▶ **FILE #:** 1-D-21-UR **AGENDA ITEM #:** 21
POSTPONEMENT(S): 1/14/2021 **AGENDA DATE:** 2/11/2021
▶ **APPLICANT:** AMERCO REAL ESTATE COMPANY
OWNER(S): Maynardville Pike LP

▶ **PROPOSED USE:** Indoor & outdoor self-storage

**1-D-21-UR
USE ON REVIEW**

Indoor & Outdoor self-storage in CA (General Business) & PC (Planned Commercial)

PROPOSED / CONCEPTUAL SITE PLAN

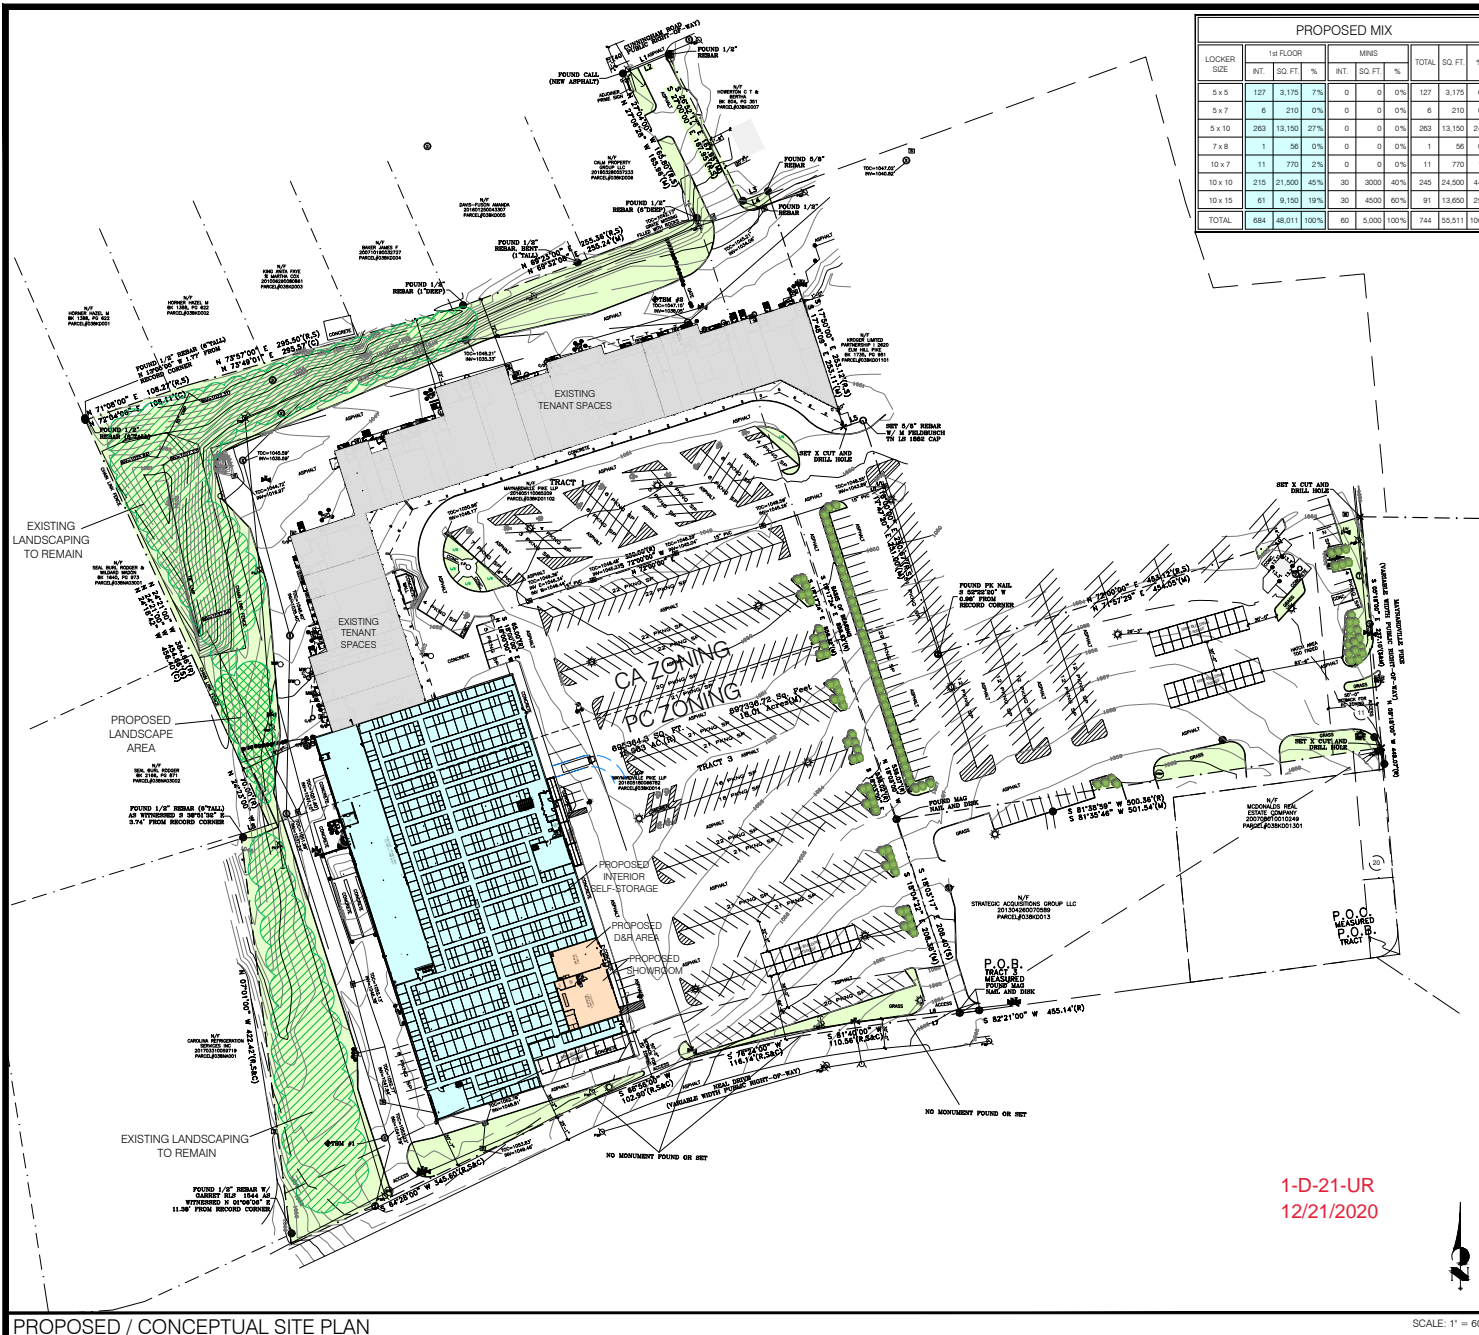
- 2) Meeting all applicable requirements of Knox County Engineering and Public Works, including but not limited to the modification of the existing parking spaces and drive aisles, and location and design of the new parking spaces in front of the building.

- 3) Meeting all applicable requirements of the Knox County Zoning Ordinance.
- 4) Providing a detailed landscaping plan for review and approval to Planning Commission staff during permit review that includes the following:

- a. Terminal islands with a minimum of 120 sqft of landscape area per row (240 sqft for double rows) with one medium to large shade tree per row.
 - b. Providing the required landscaped buffer adjacent to the residentially zoned property to the west and along the Neal Drive frontage per the standards for indoor self-storage facilities (Section 4.93.03.E. & F.).

- 6) Meeting the building architectural and material standards for indoor self-storage facilities (Section 4.93.03.J. & K.).
- 7) Relocating the light pole and fire hydrant that is within the relocated drive aisle as a result of removing spaces at the end of two parking rows.

The outdoor self-storage units are proposed in two locations in the parking lot of the shopping center and along the southeast side of the building. Staff is recommending denial of the outdoor self-storage use because it is not a compatible use within a shopping center where there are other businesses within the unified development. The reduction in parking as a result of the outdoor storage units is not a concern with the current or potential future uses within the shopping center.
